Western & University

Design Review Board Recommendation Meeting

MACK URBAN & ANKROM MOISAN ARCHITECTS, INC.
DPD #3014451 / **19 AUGUST 2014**

WESTERN AVE & UNIVERSITY ST PODIUM CORNER REVISED (DRB 2) OPTION 1 SHADOW BOX (PREFERRED)

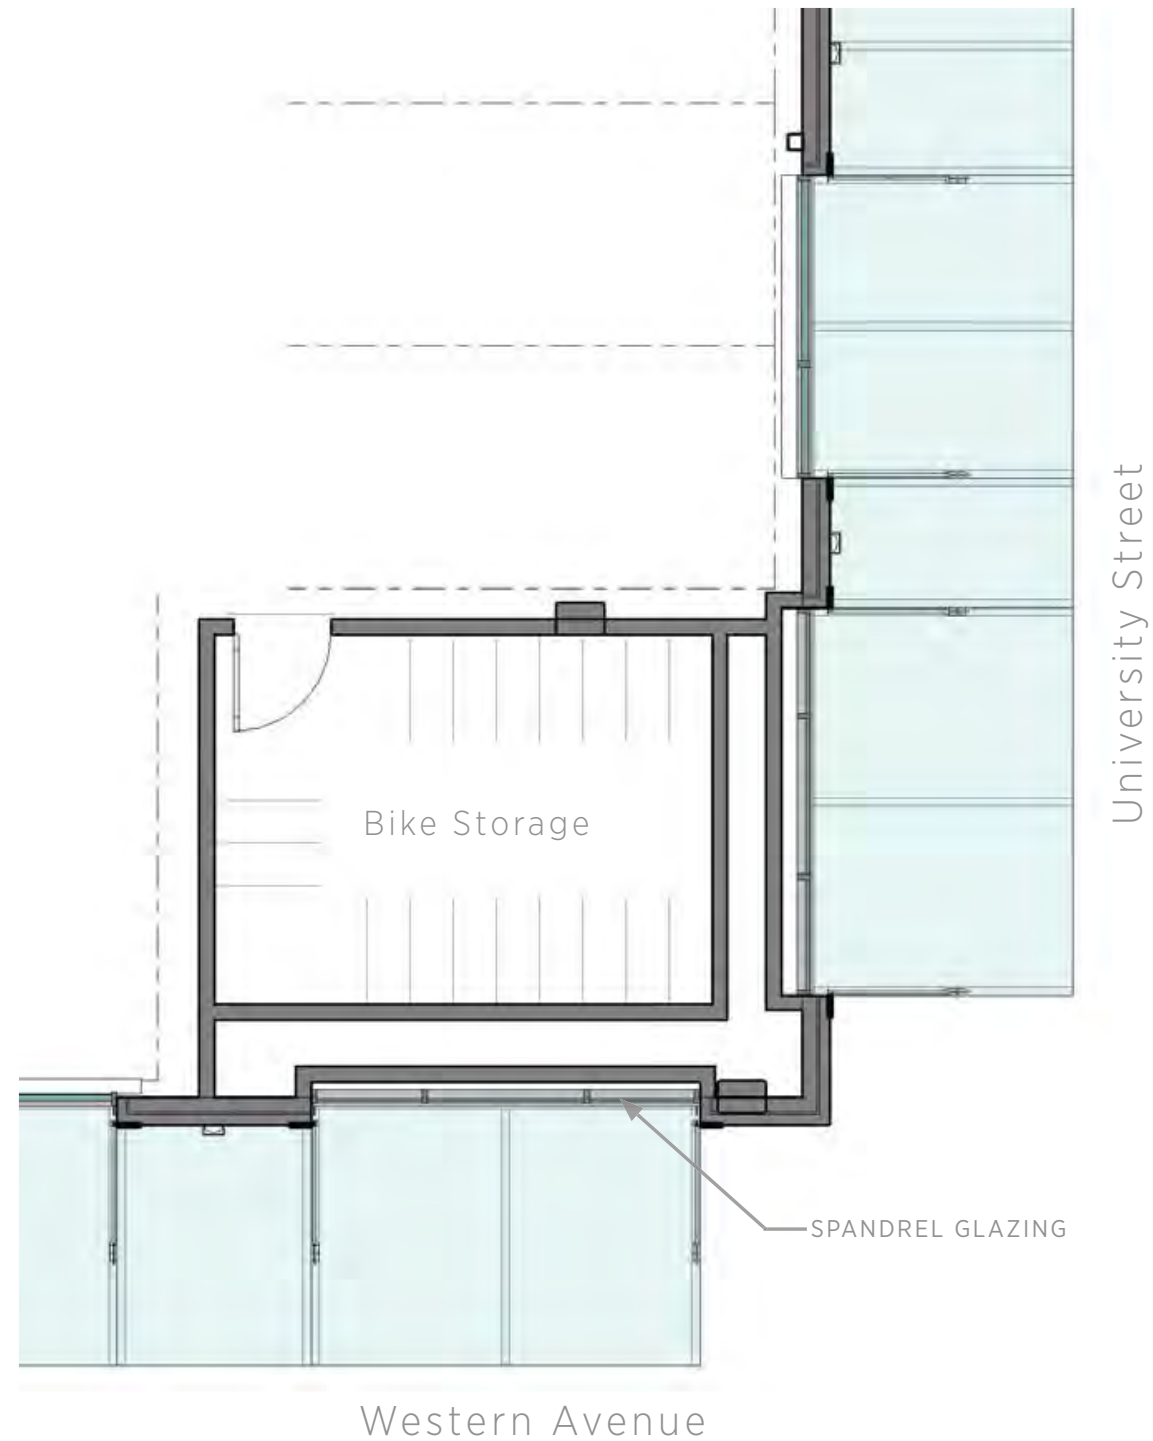
“At the EDG meeting, the Board conveyed its desire to see a more active use at the second floor corners and suggested, as one solution, doubling the height of the corner spaces at the first floor. The Board members reiterated their expectation and recommended that the University and Western corner have a double height space with transparent glazing.”

The design team has identified two schemes for the podium corner at Western Ave and University Street that could better activate the streetscape.

The first and preferred option, a storefront “shadowbox” would feature an upper level display space that would help create visual interest for the streetscape but also leave room for required mechanical equipment.

REVISED STREET LEVEL CANOPY COVERAGE (DRB II)

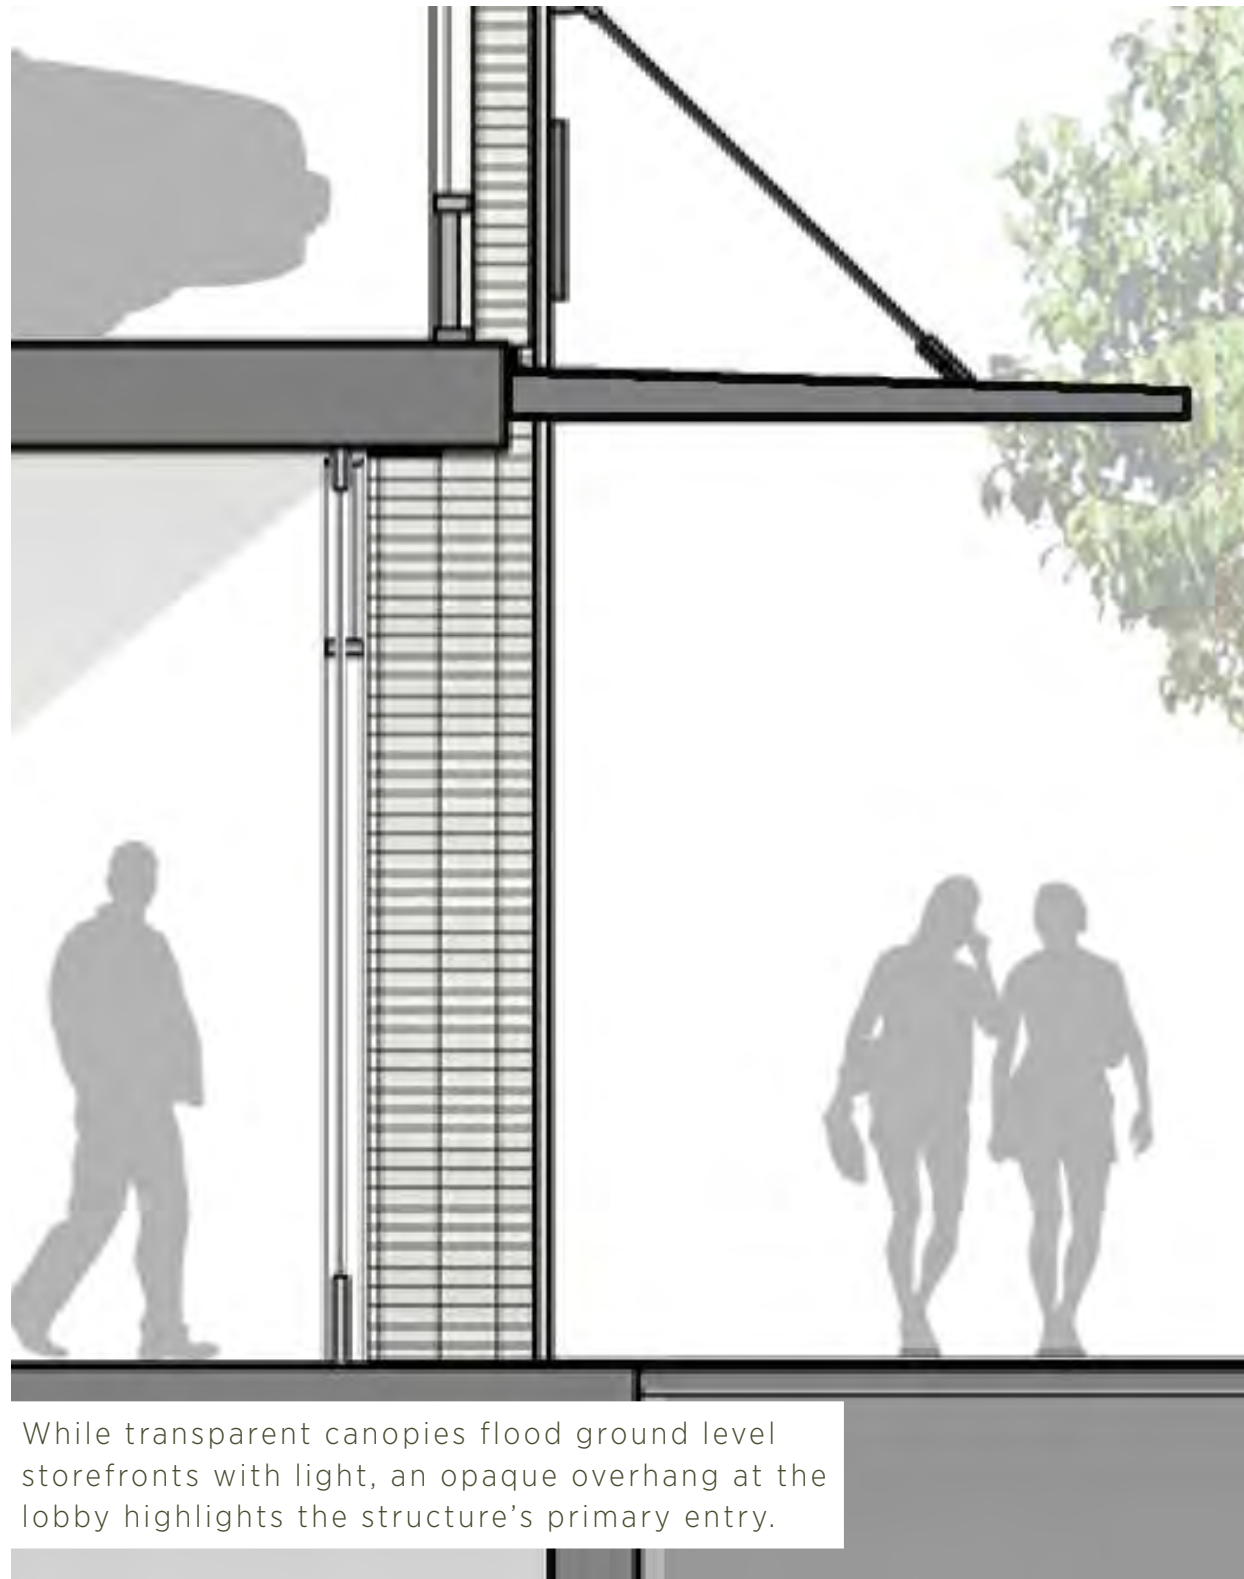
“The canopies should constitute a nearly continuous covering over the three sidewalks with the possible exception of the corners.”

“The Board recommended eliminating the opaque material in favor of the transparent glazing providing greater homogeneity along the building fronts.”

“With the Board recommending that all of the canopies have glazing the entry lacks a distinguishing feature seen from afar due to the recessed doorway.”

The canopies have been lengthened to provide nearly continuous cover over the sidewalks and revised to feature transparent glazing for the majority of the street frontage.

The main building entry on University Street is denoted by pin mounted signage and an opaque, wood paneled soffit which punctuates the transparent canopies.

A departure is requested to omit canopy coverage at the corners.

REVISED ALASKAN WAY (WEST) ELEVATION (DRB II)

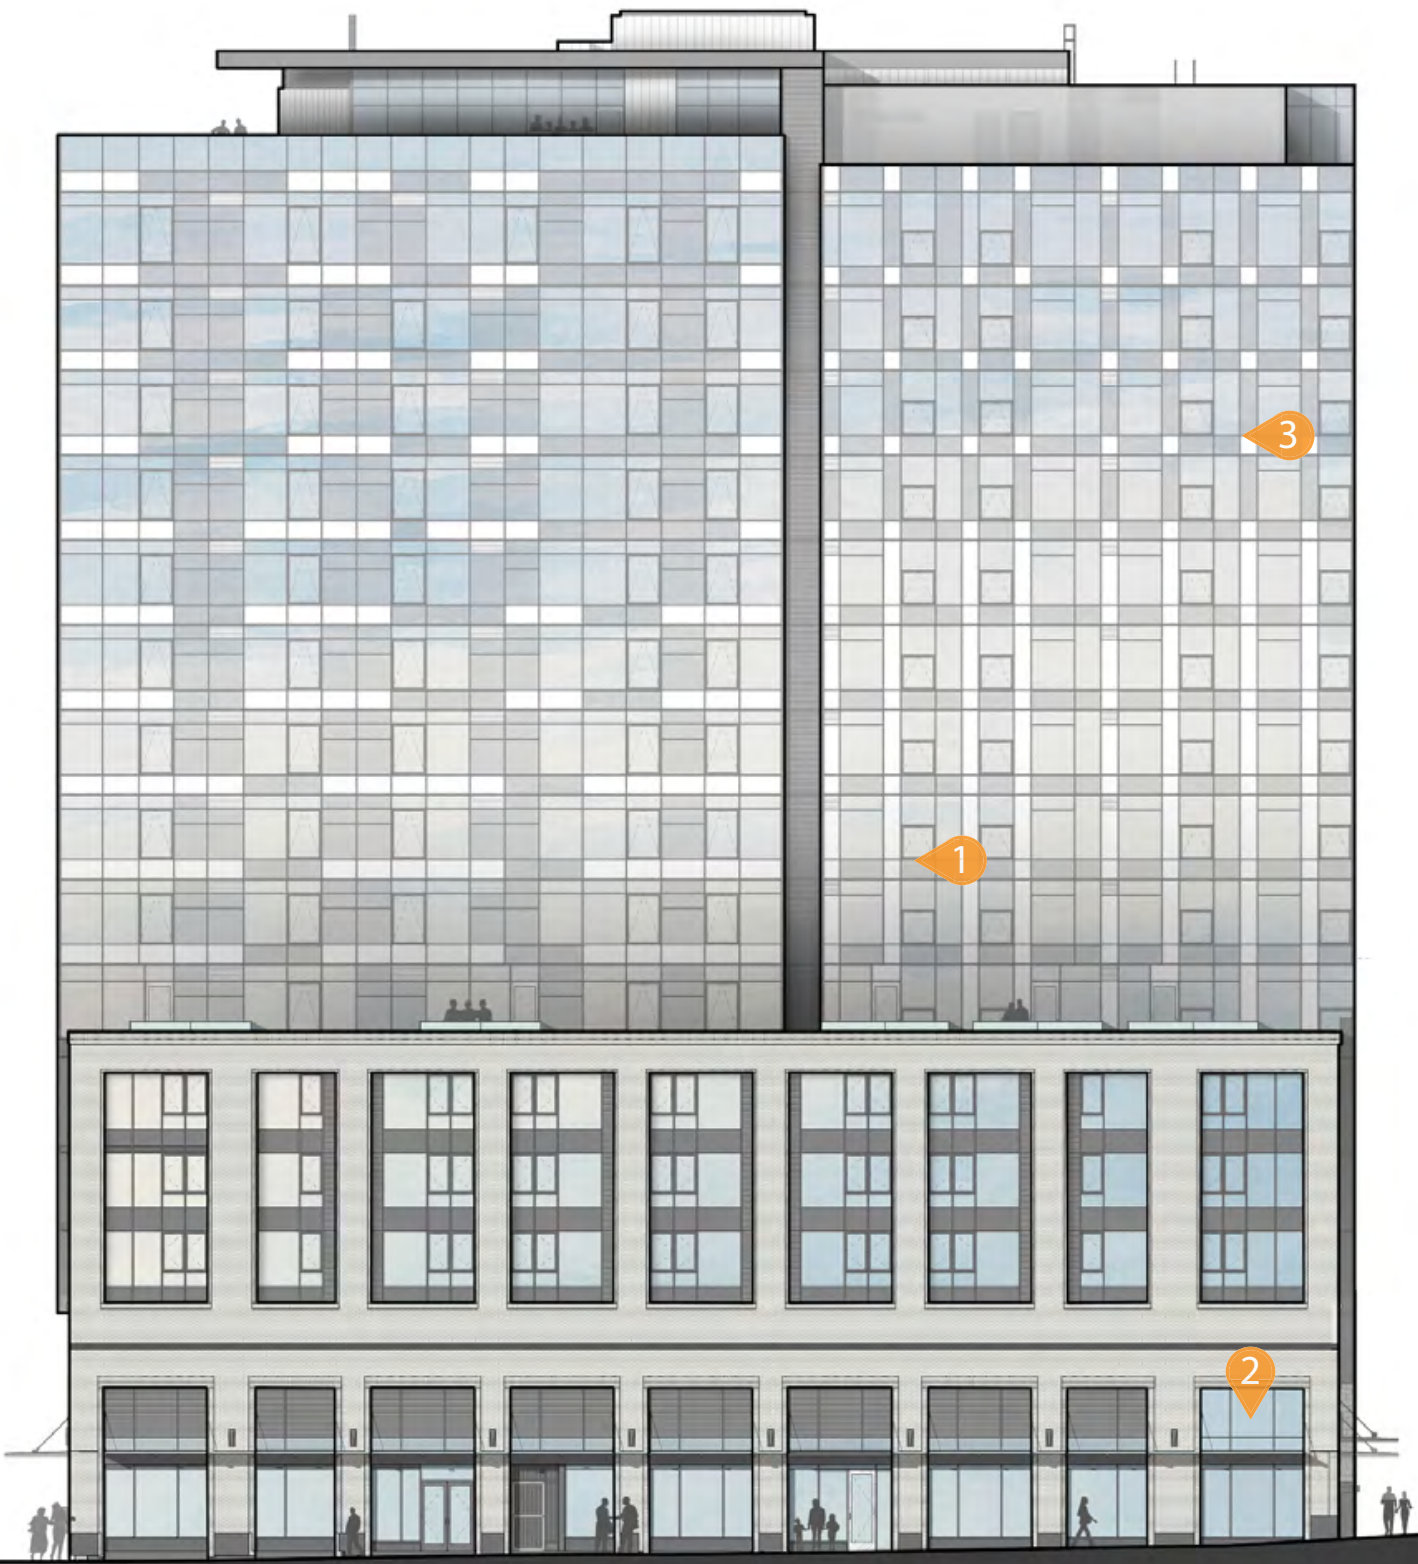
“The masonry portion of the three upper levels should extend northward to the vertical edge of the tower in order to eliminate the gap between the edge and the masonry.”

“On the east and west elevations, the Board recommended that the brick reveals should be narrowed and the masonry replaced with the same metal louvers elsewhere on the facades.”

In an effort to create a composition that is more pleasing to the board, the relationship between the tower and podium elements has been simplified to read as two, more distinct, elements. The glazed portion of the tower on Alaskan Way has been brought northward to create a stronger southern edge and pushed upward to float above the ground level storefronts.

On all facades, the brick reveals intended to recall the adjacent steam plant smokestacks have been narrowed and replaced with metal louvers.

REVISED UNIVERSITY ST. (SOUTH) ELEVATION (DRB II)

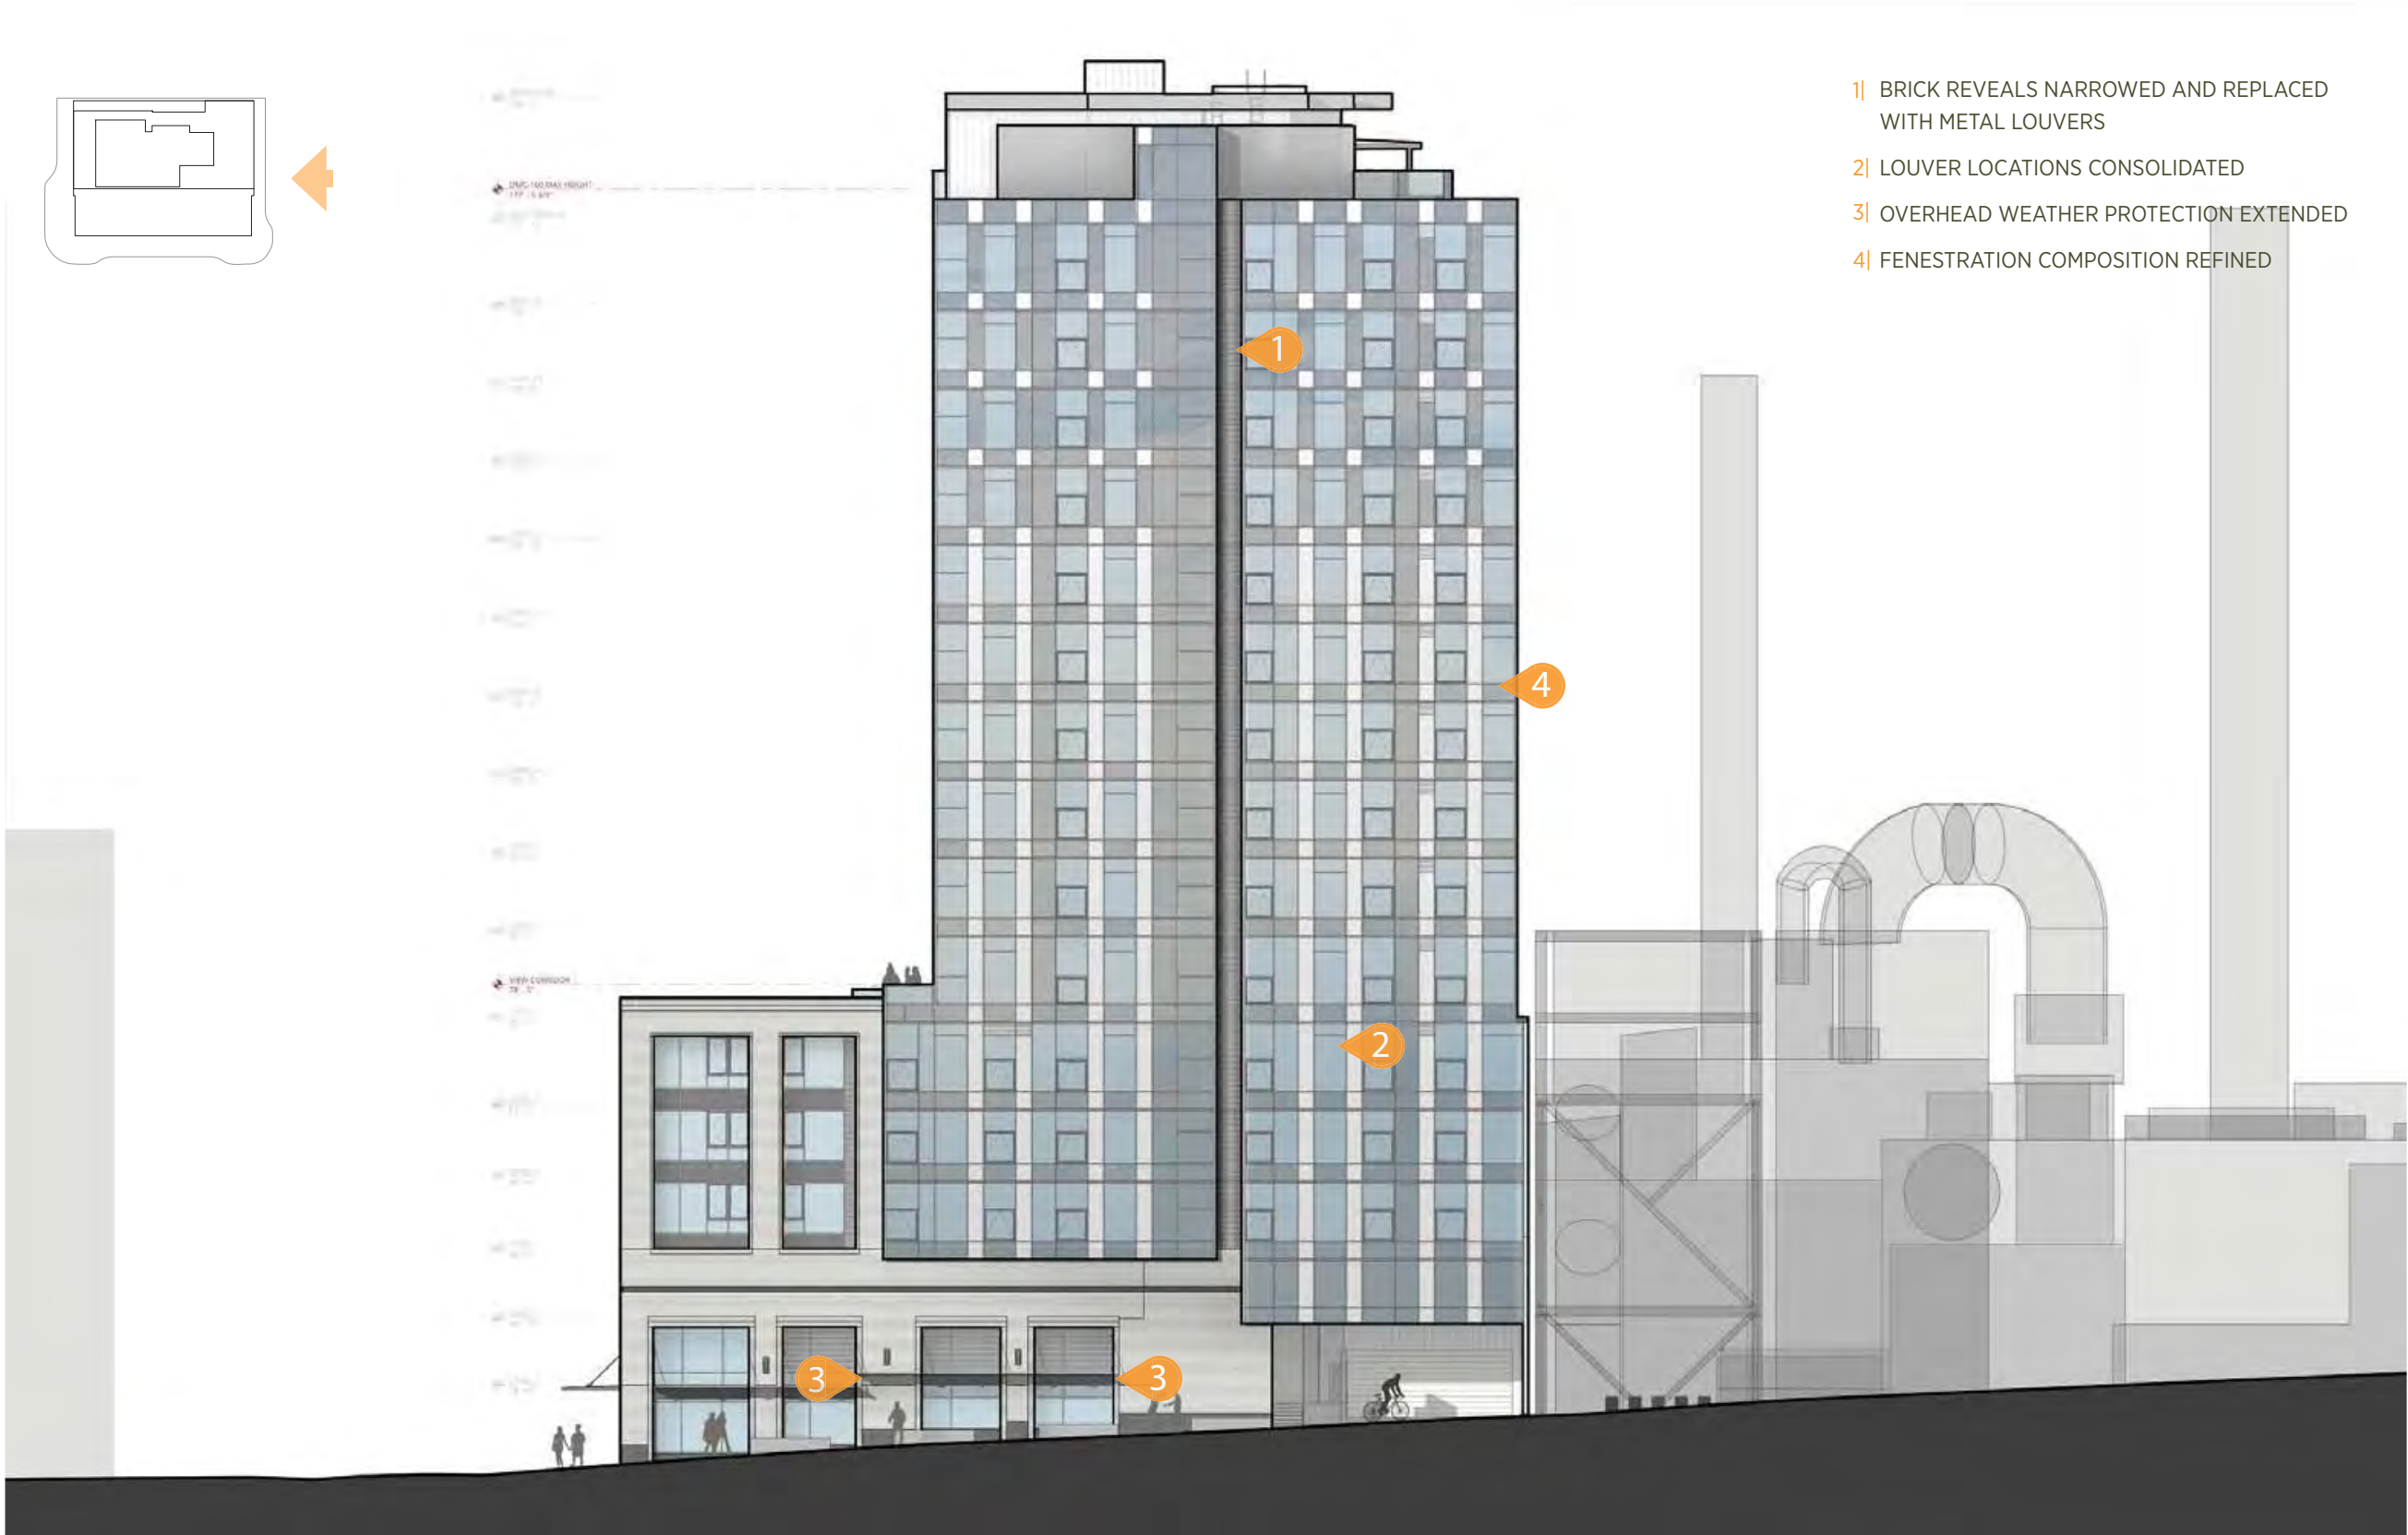
“Using the imagery of rising steam or vapor as well as the Steam Plant’s chimneys to inform the design of the building skin generally produced busy elevations.”

“The Board also requested more accurate drawings of the facades with the distinctions in color between the spandrels and the windows more honestly rendered.”

- 1| LOUVER LOCATIONS CONSOLIDATED
- 2| OVERHEAD WEATHER PROTECTION EXTENDED
- 3| FENESTRATION COMPOSITION REFINED
